# Technical Bulletin

Bulletin Number: TB 500 Revision Number: R-03

**SUBJECT:** COIN CHUTE ALIGNMENT WITH TOP OF COIN MECHANISM

**MODELS AFFECTED:** All VRV Models with Vender Defender Coin Chute.

Figure 3

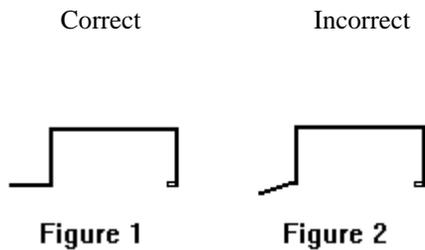
Note: There should be a 90° break in the flange as shown in figure 1. Figure 2 shows a flange that is not made properly and the flange is not at 90°. This will cause alignment problems with the coin chute and changer.

1. Check the depth of the access door at the top and bottom. See figure 3. The measurements of "A" and "B" should be the same. If these are off it will cause alignment problems with the coin chute and changer.

To correct the problem, the customer can replace access doors with serial numbers as a warranty exchange. If items 1 and 2 check out O.K., then the customer can try longer changer mounting screws with nylon bushings listed above.
